AMMONIA-UREA FERTILIZER COMPLEX AT NAMRUP, ASSAM
[NIT NO. PNMM/PC230/E/001 DATED 20.11.2025]

CORRIGENDUM-4 TECHNICAL (PROCESS) DATED 10.02.2026

AMMONIA UREA FERTILIZER COMPLEX AVFCCL, NAMRUP DESIGN PHILOSOPHY – INSTRUMENTATION	PC230/E-001/P-II/5.4	0	
		DOCUMENT NO	REV	
		SHEET 128 of 128

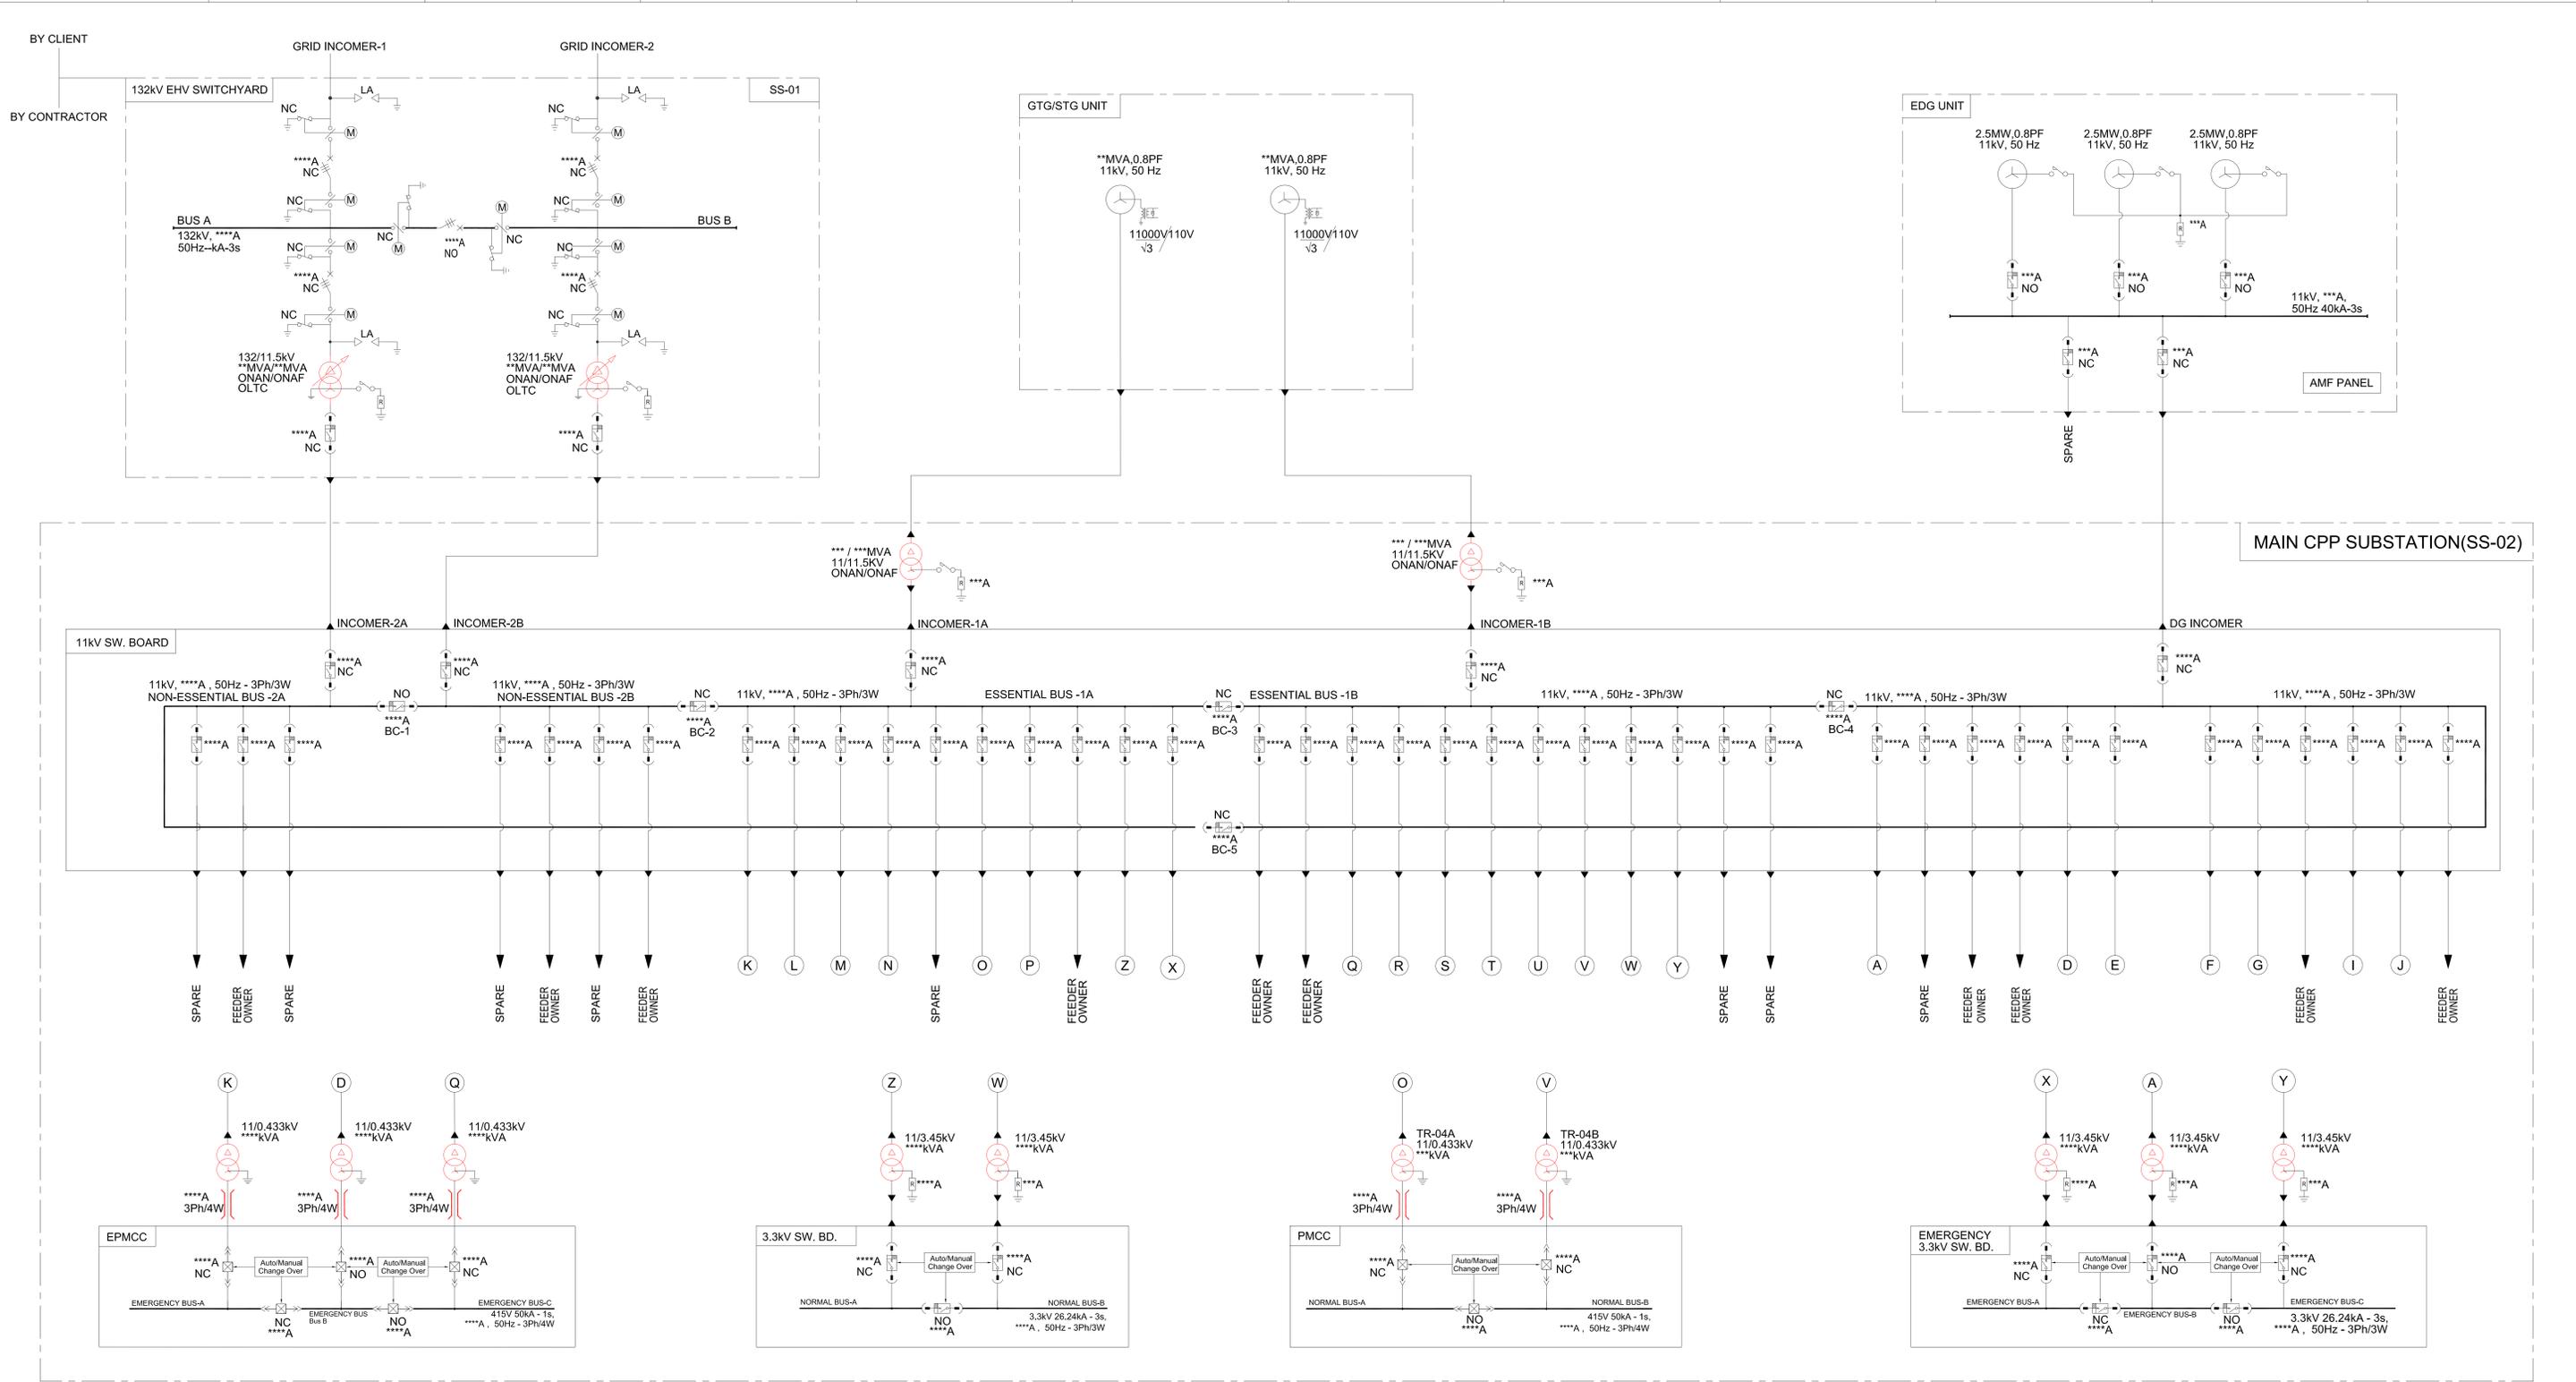
26.	SEC – 5.4	SHEET 121-127 of 127	ANNEXURE -3	SYSTEM CONFIGURATION	M	Attached Annexure 3 shall be considered instead of NIT Annexure-3.  Annexure-3.pdf
